# Tampa Electric Company (TECO)
# Coal Yard Assessment
## Stantec Job No. 198800347

September 2010
Revision 2

Stantec has been retained by Tampa Electric Company to provide a review of the coal field equipment at the Big Bend facility. The review scope boundaries are from the dock through conveyors L1 and L2 that bring the coal to the tripper deck in the power house.

Continental Conveyor Drawing W-615-E48-A

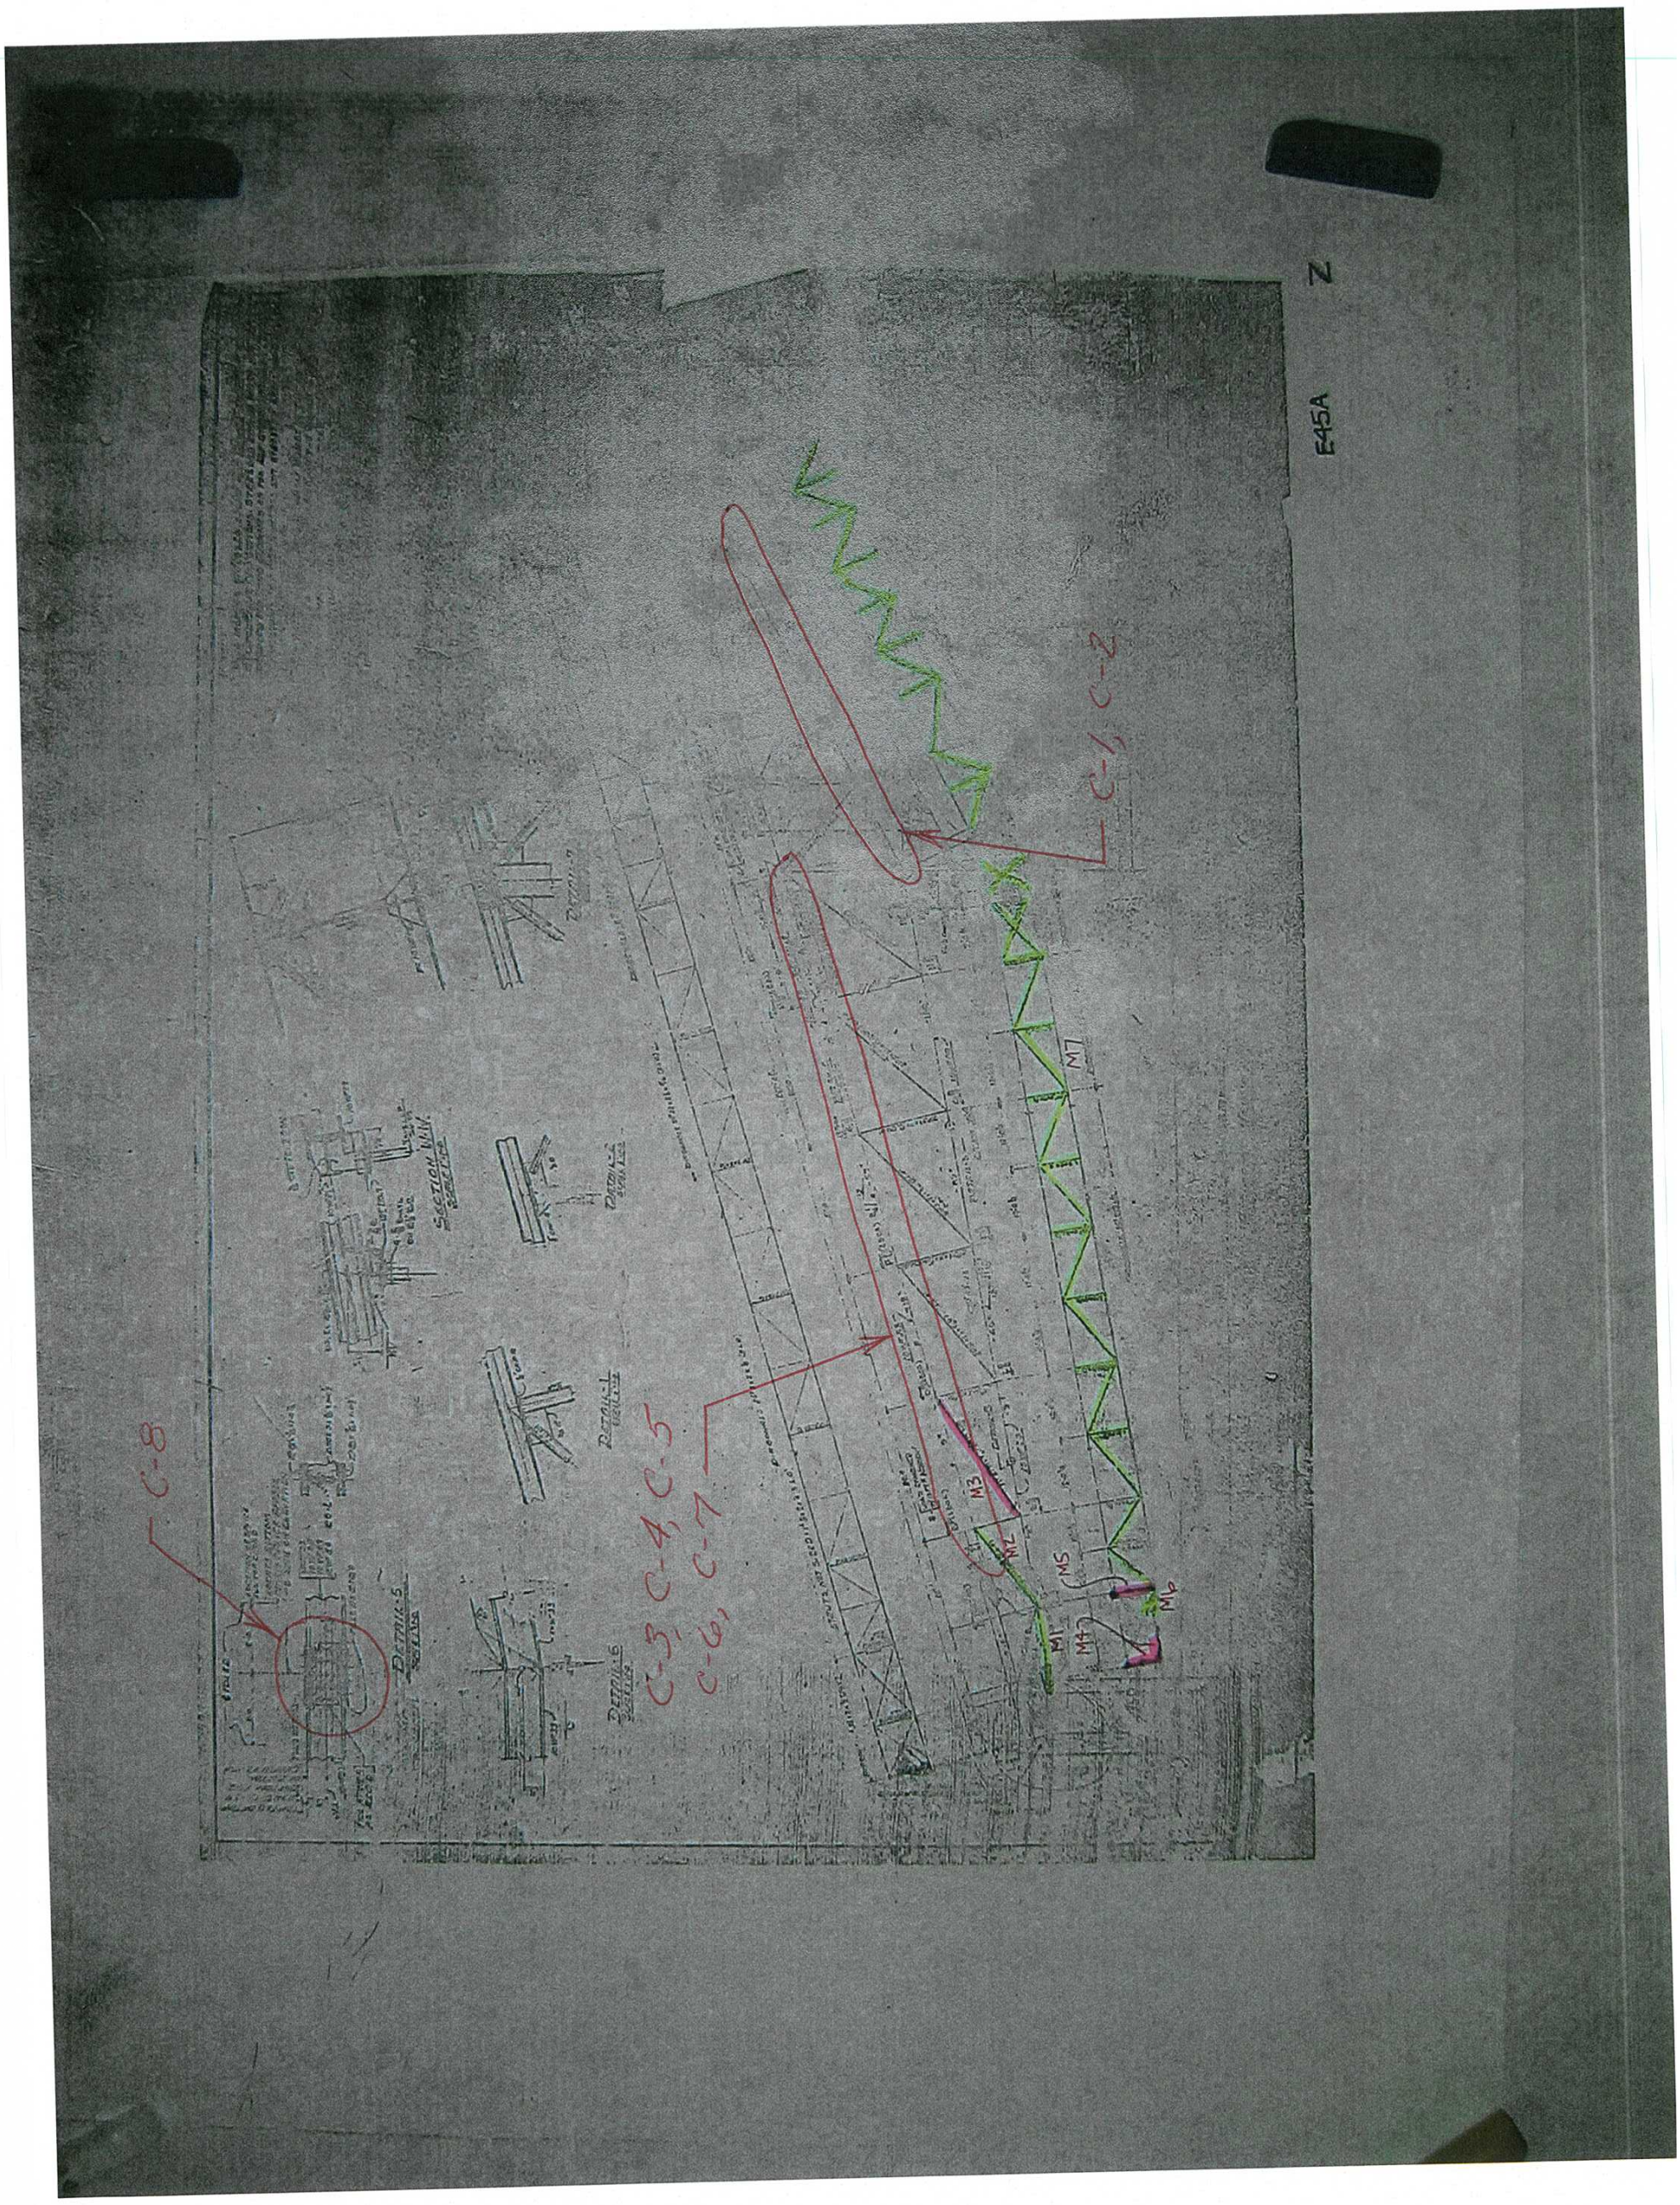
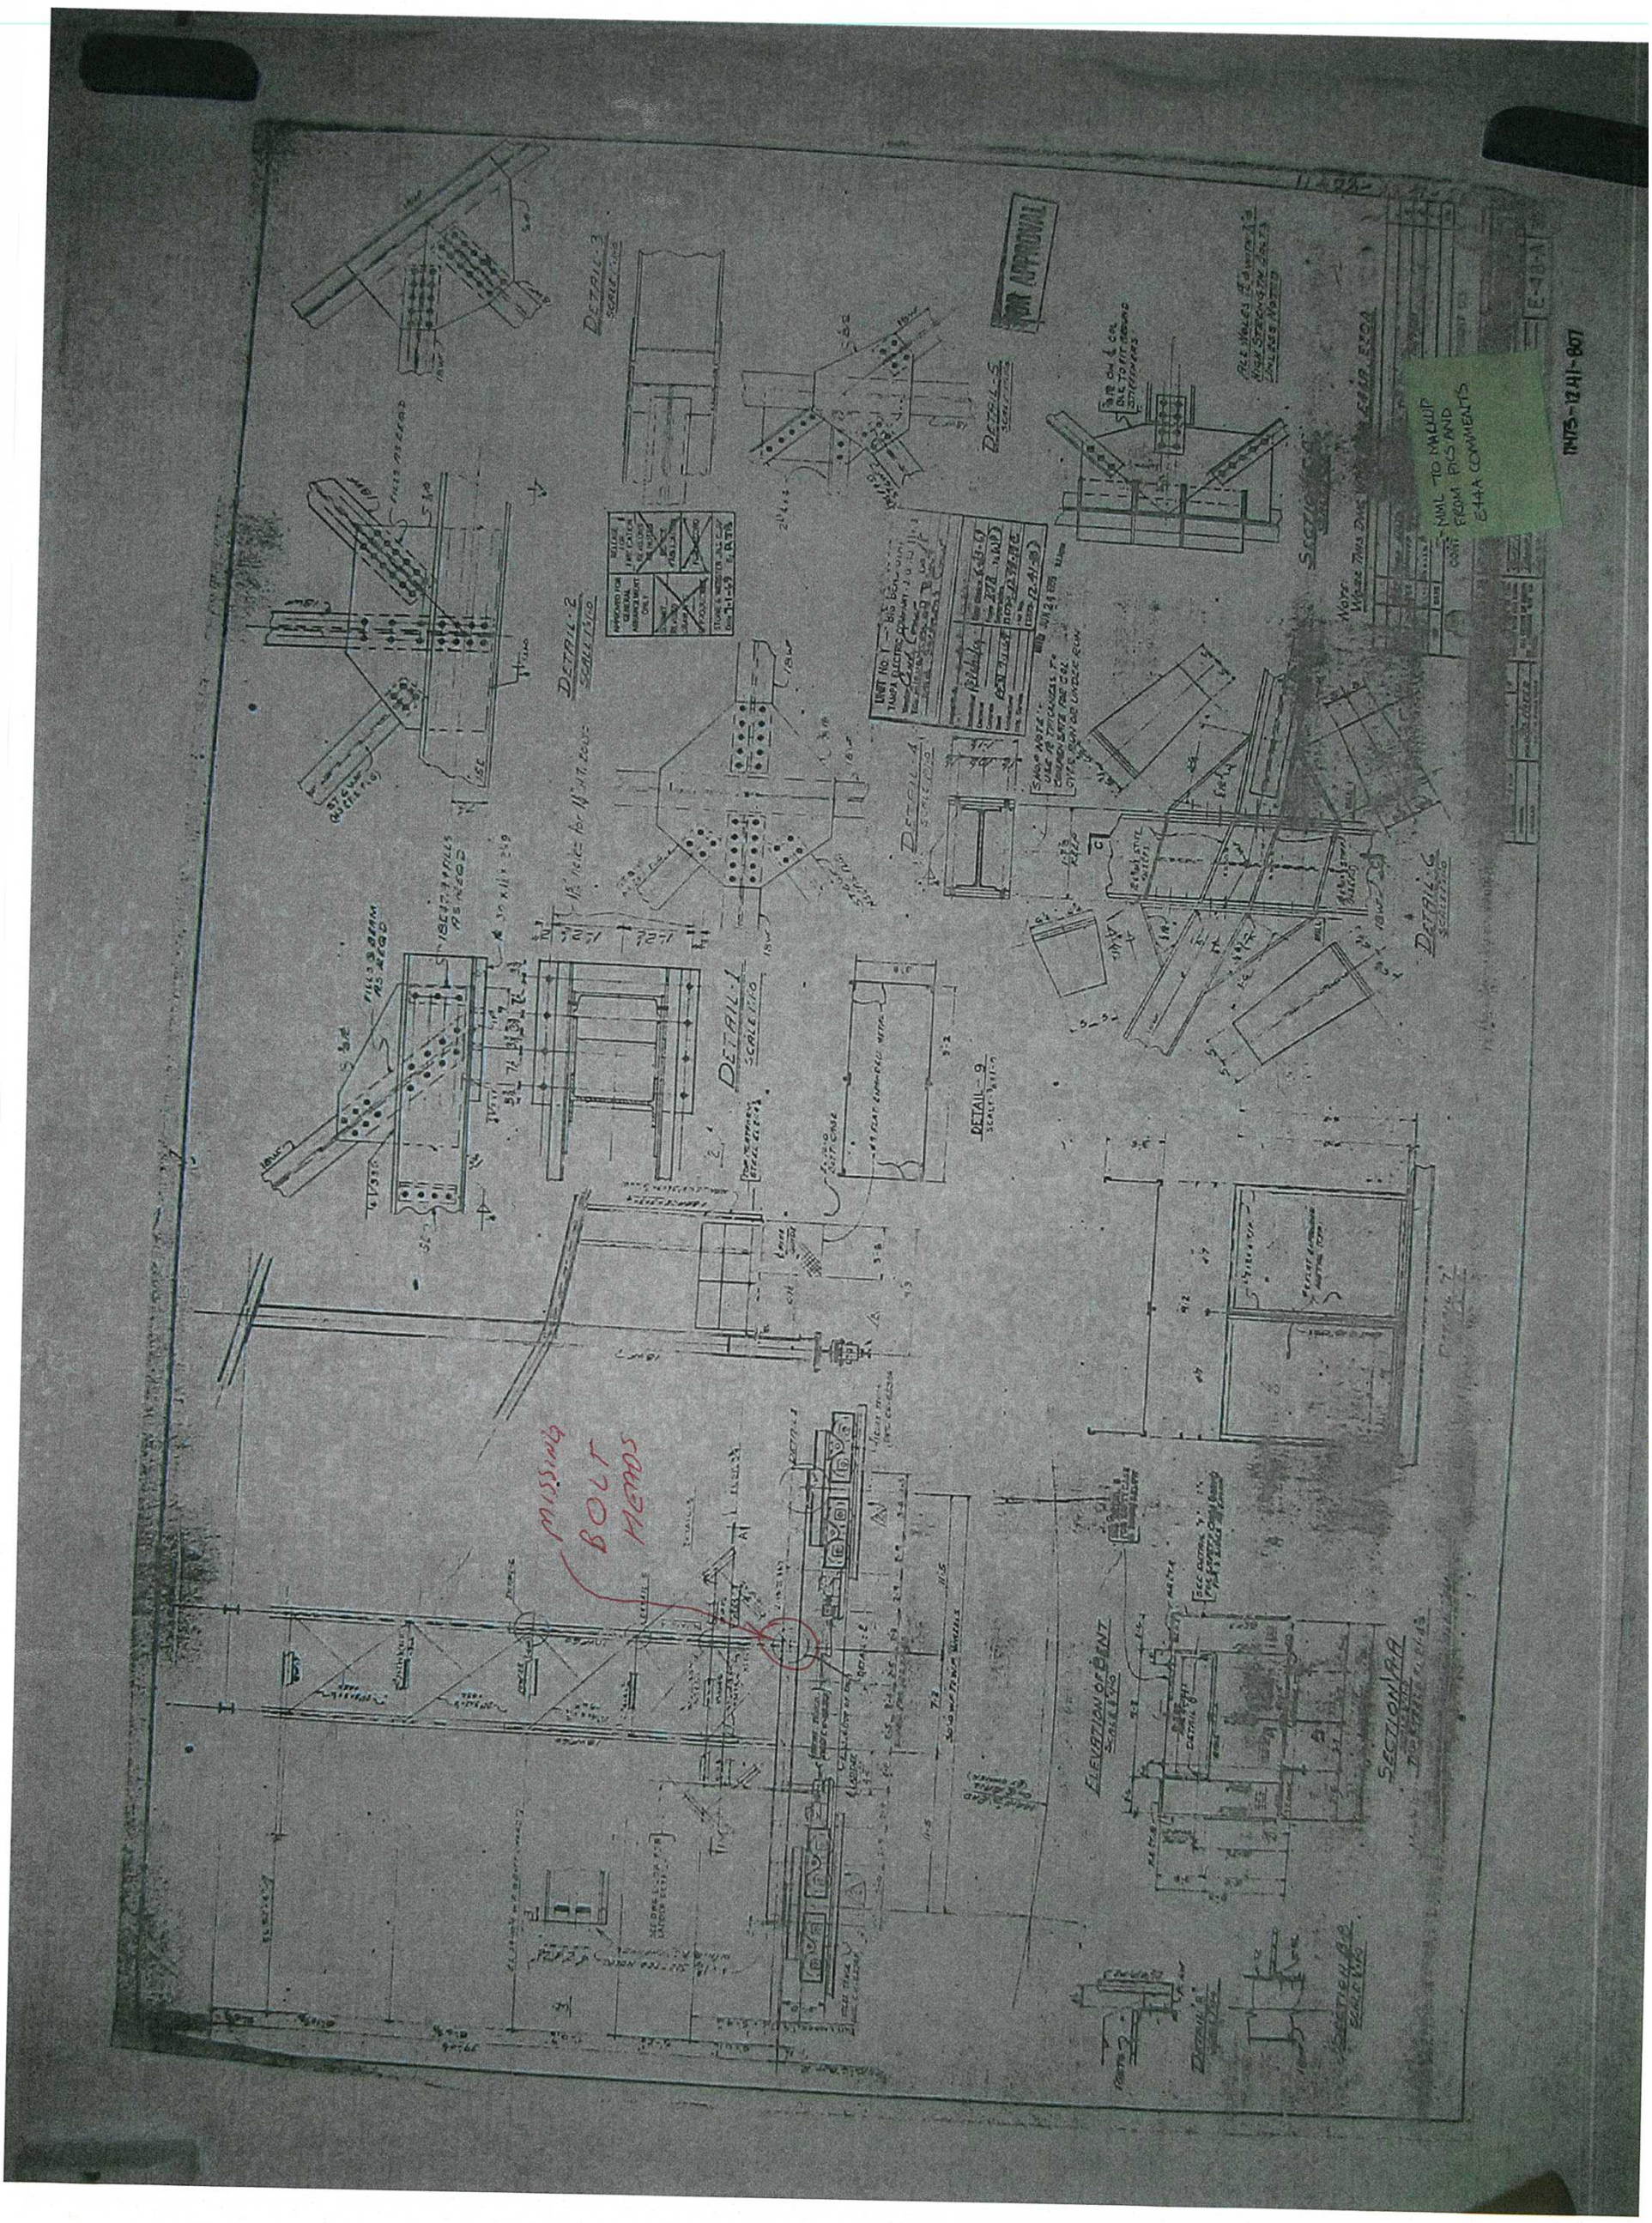
At the bottom of the pivot bent, there are some missing bolt heads on the inside surfaces of the gusset plates at the location of Detail 2 on the drawing on the west end. These may have fractured off when the conveyor overturned previously. This bent also needs some cleaning and painting.

PICTURE TTWR-T4-K

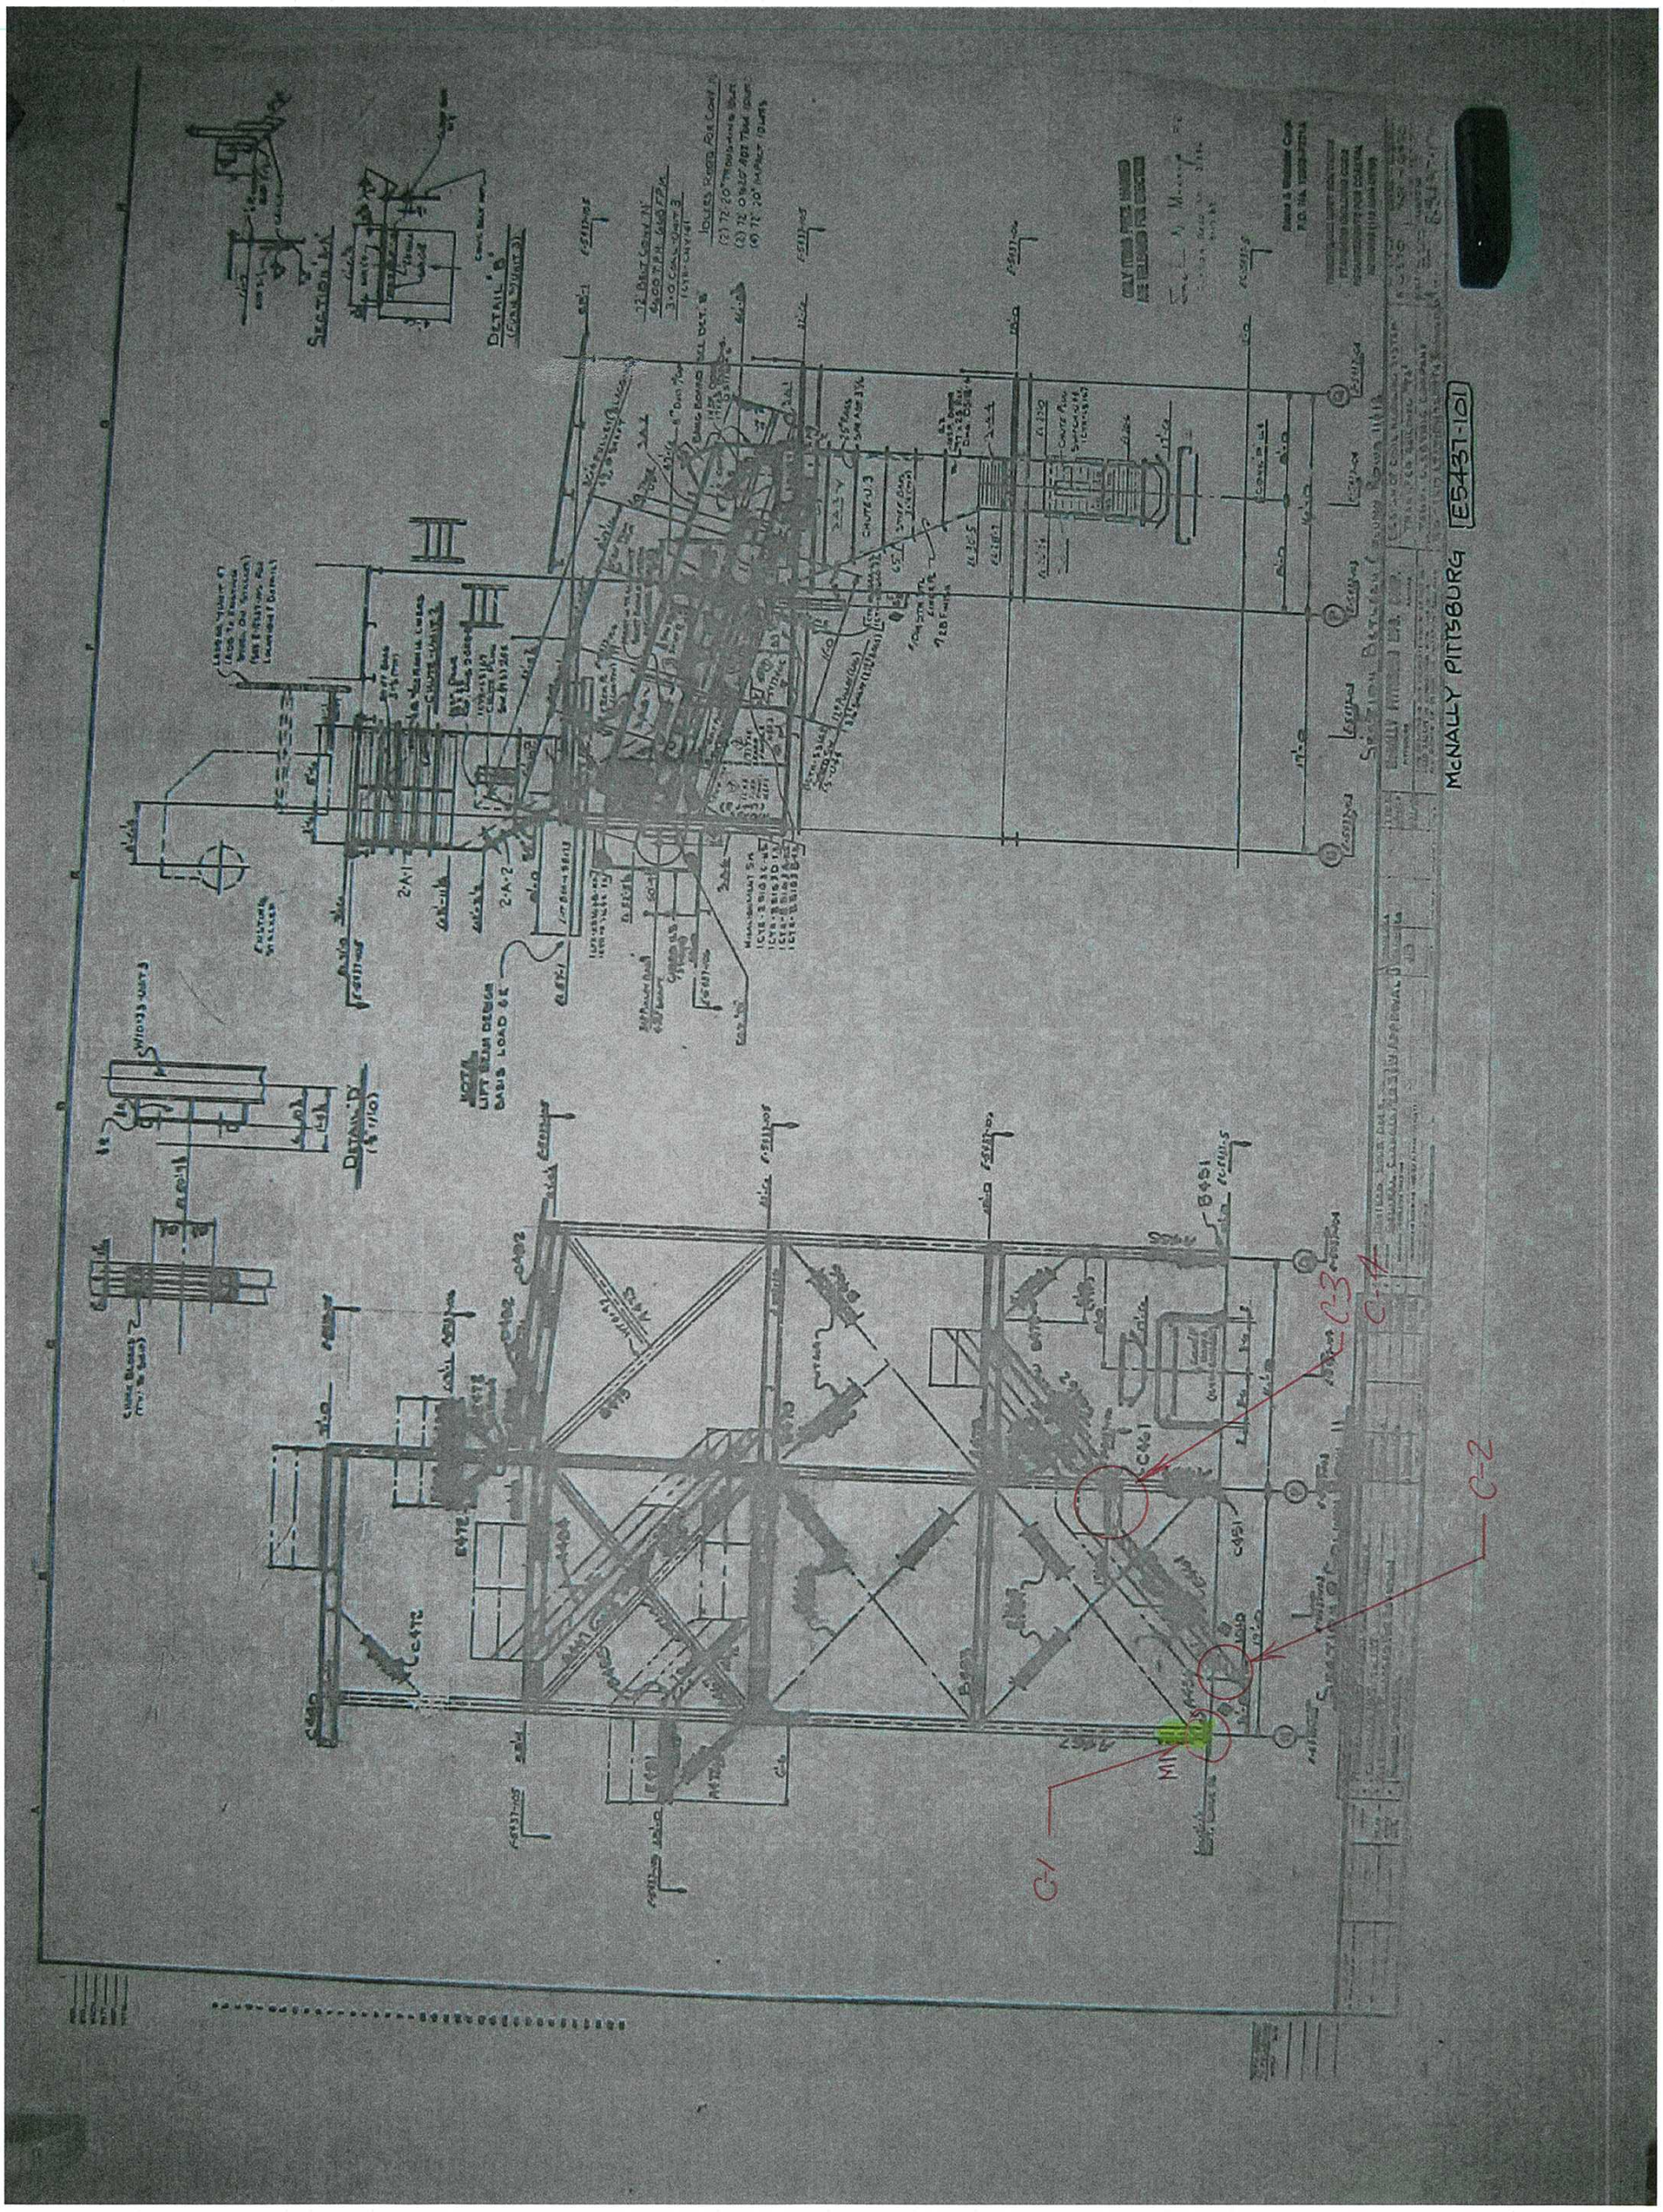
C-1 The ladder from the top of conveyor Z to the top of transfer tower T-4 does not appear to comply with OSHA requirements. The toe plate directly below the ladder, as seen in picture TTWR-T4-K provides a tripping hazard for anyone using the ladder. Also, the ladder itself should be over the grating of the lower platform, not beyond it. The ladder should be extended out over the lower platform or the toe plate removed and a landing behind the ladder added that complies with OSHA regulations.
